MEMORANDUM

TO: Water Right File 63-34025

SUBJECT: Licensing Review of Water Right 63-34025

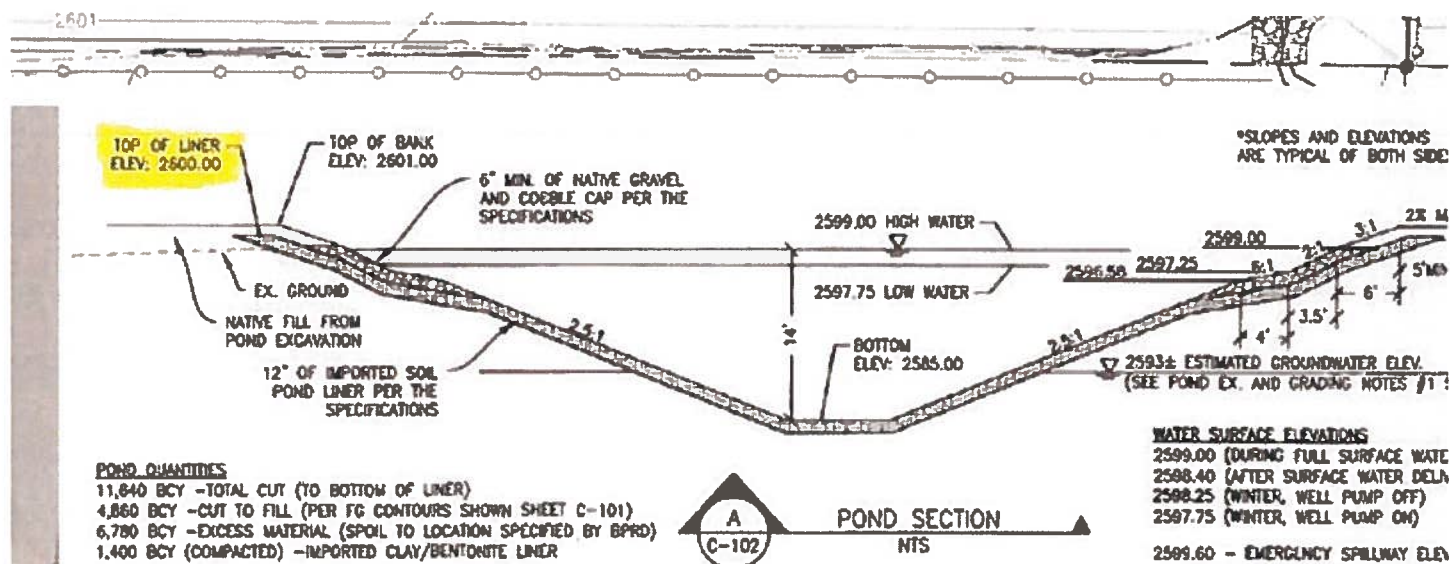
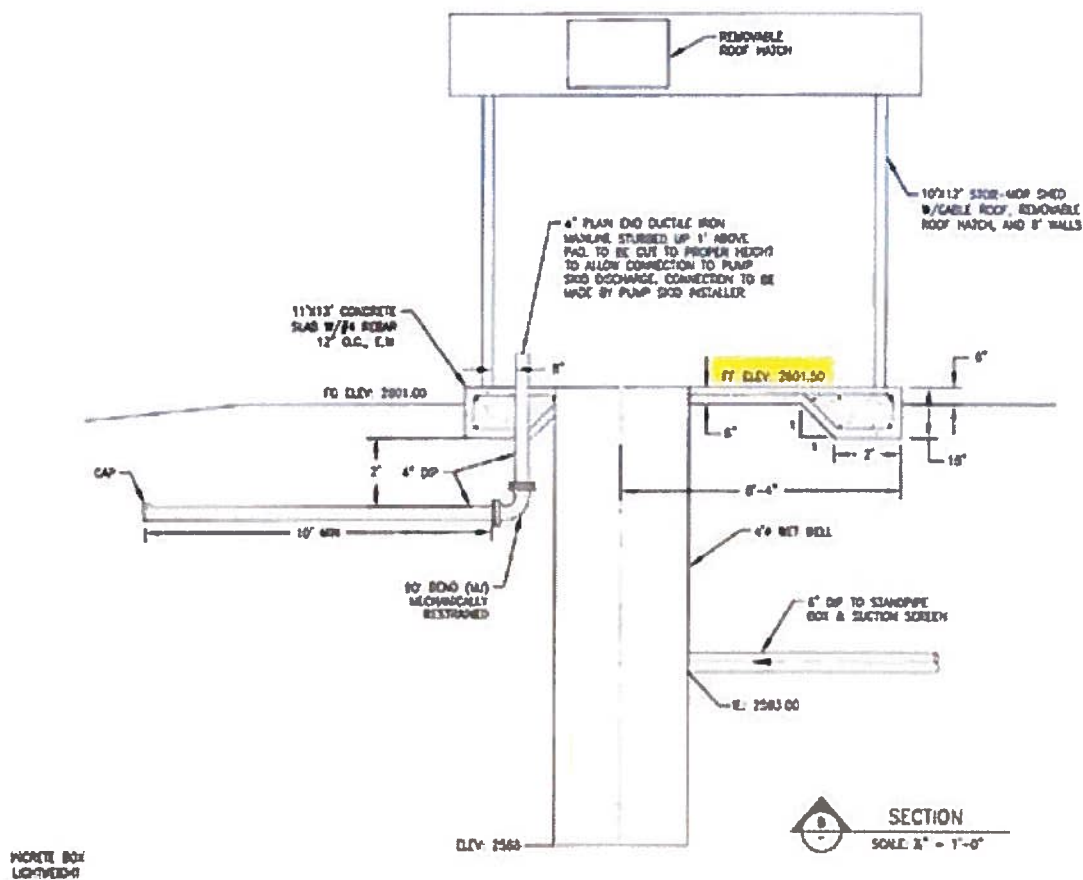
See test information below and attached. It looks like the pond was leaking at more than 1" per day when full last year. When the water level falls far enough, it probably equalizes with groundwater level as you suggested which eliminates seepage.

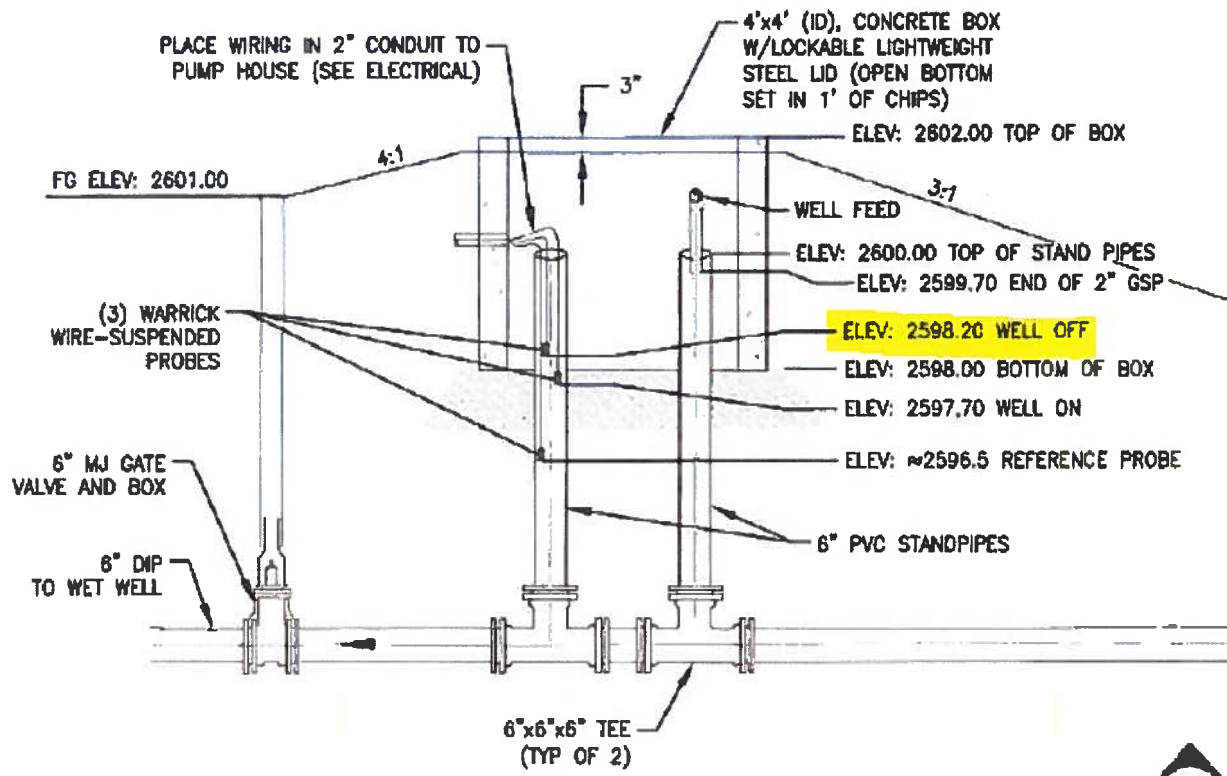
I understand that bentonite is being added around the banks and will be retested this fall to confirm that it meets the 1/2 " specification. However, at the time of the exam, the pond was full and I assume it was leaking more than 1/2" per day.
